DEVELOPMENT REVIEW BOARD REPORT

**FEV2 Office Remodel
3-DR-2023** | Request for approval of a site plan, landscape plan, and building elevations for an exterior remodel to an existing office building on a +/- 2-acre site.

3-DR-2023

Planting Plan

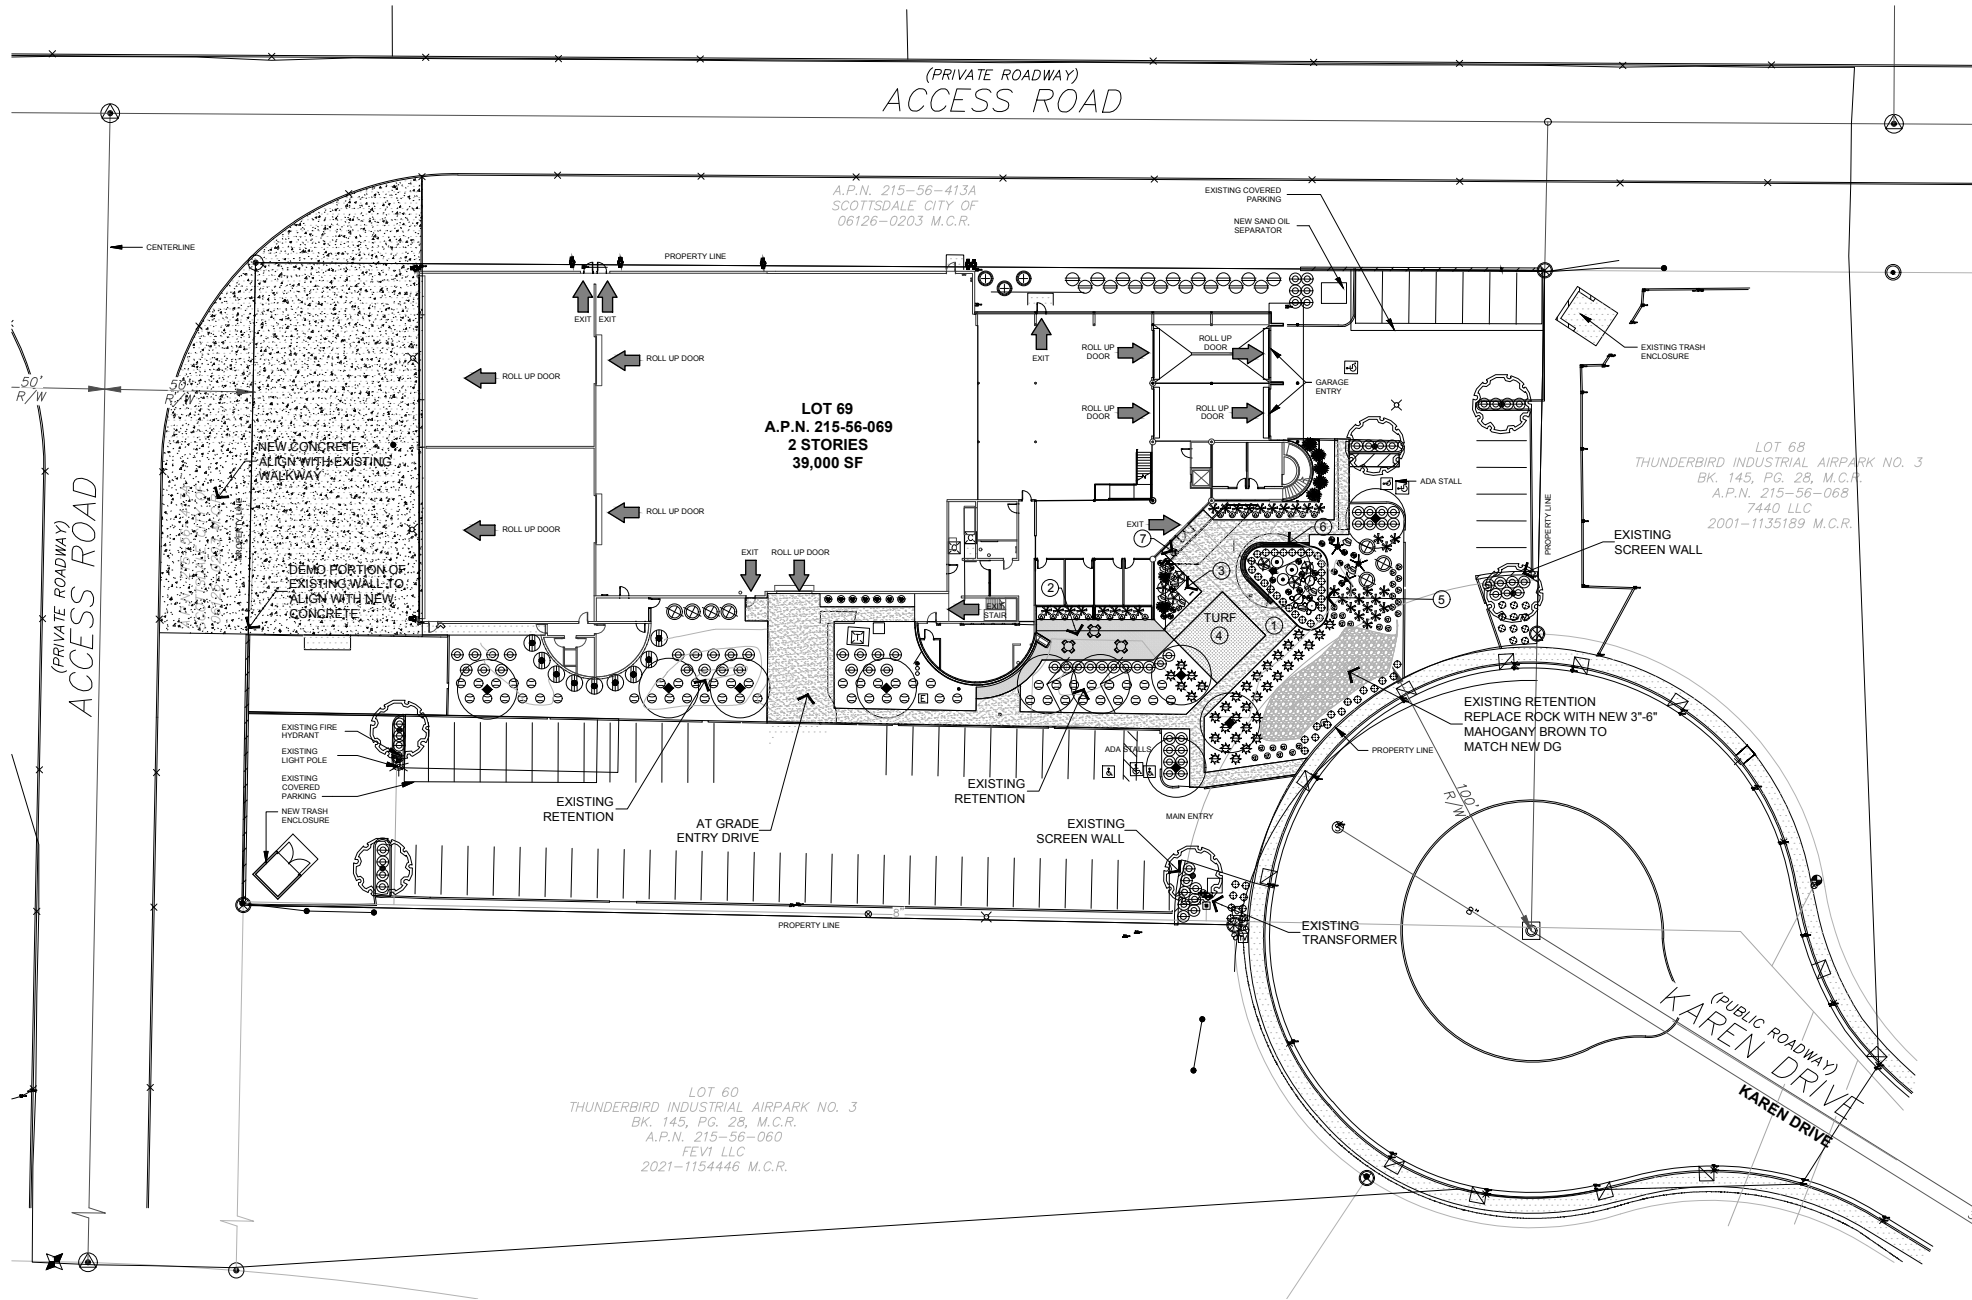
Looks like they intend to remove all trees and replace with Hesper aloe . I'm all in favor of using desert vegetation to replace grass. I hope they plan to salvage the palms and plan a more interesting, native flora/fauna friendly landscape. -- sent by Cathy Davis (case# 3-DR-2023)

- C. With final plans submittal, the owner shall update the landscape plans to show all utility lines and ensure that all new trees are placed at least eight (8) feet away from any utility lines.
- D. With final plans submittal, the property owner shall update the landscape plans to show that thorny trees, shrubs and cacti will be planted so their mature size/canopy will be at least 4 feet away from walkways or parking area curbing.

A302
EXTERIOR ELEVATIONS
- DRB

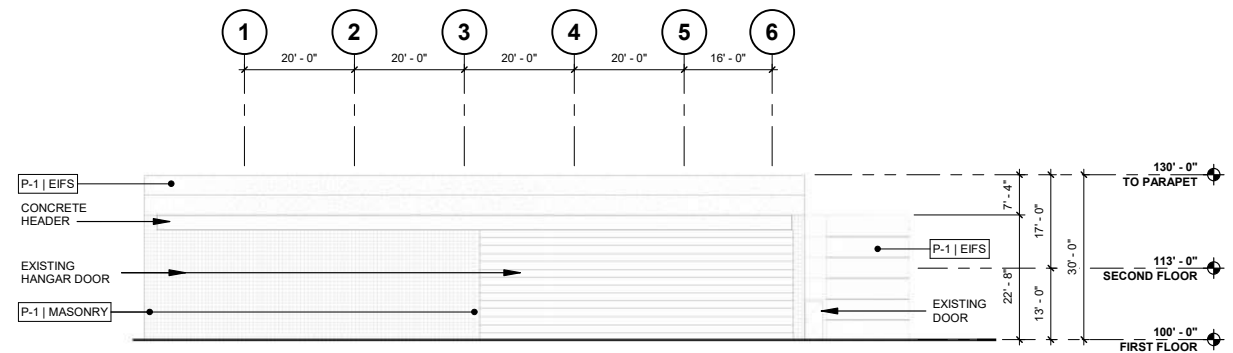
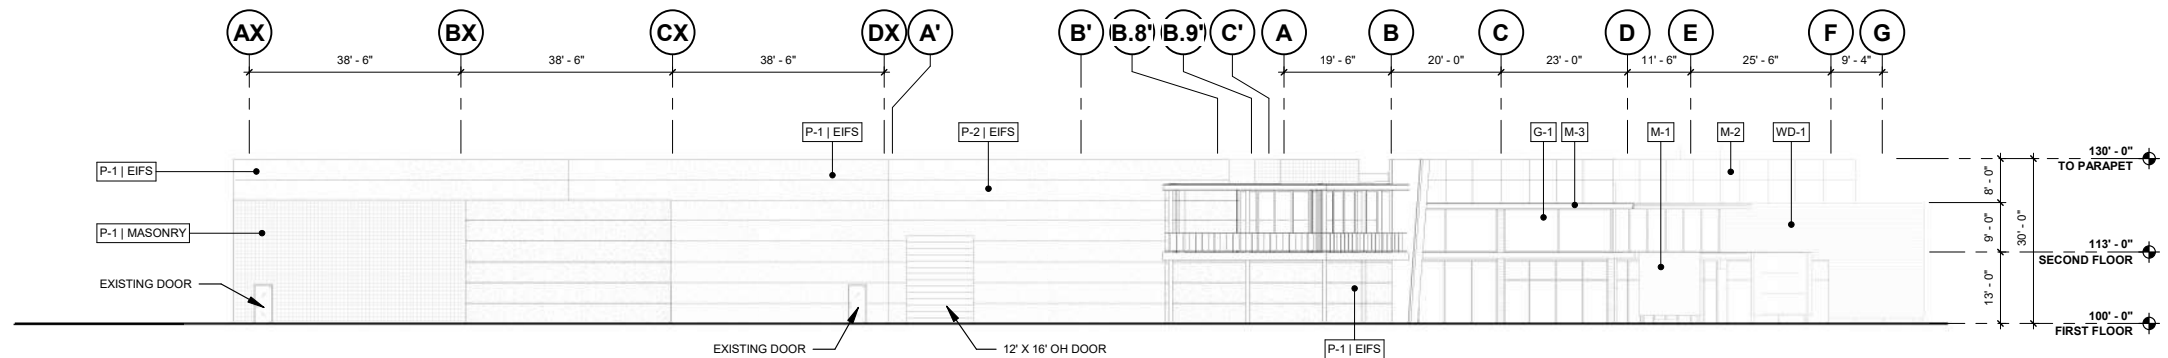
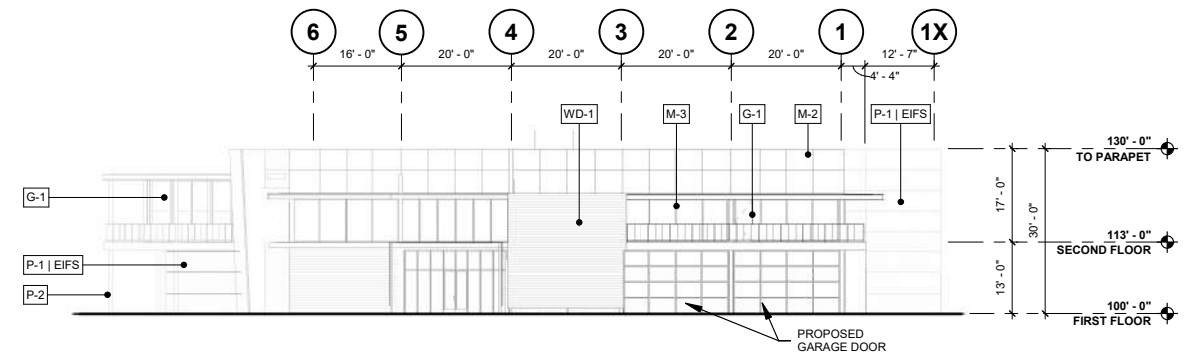
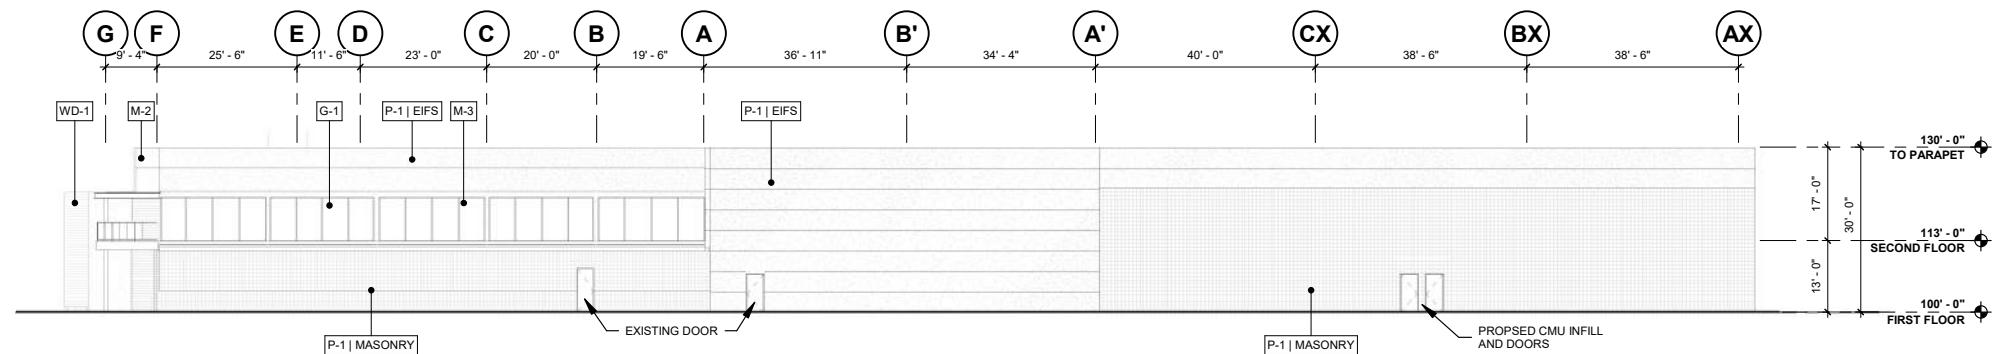
- *Staff finds that the proposed development exhibits a compatible approach to the surrounding context. The building has a contemporary design that utilizes a variety of materials with adequate massing and shading to avoid monotonous repetition. However, Staff notes that the use of dark-cool paint tones may not promote a desirable color scheme in all contexts. Warm neutral tones are more compatible with the Sonoran Desert. The site is not located within the ESL Overlay nor the Historic Preservation Overlay District.*

- a. Architectural elements, including dimensions, materials, form, color, and texture shall be constructed to be consistent with the building elevations submitted by Nelsen Partners, with a city staff date of 3/9/2023.
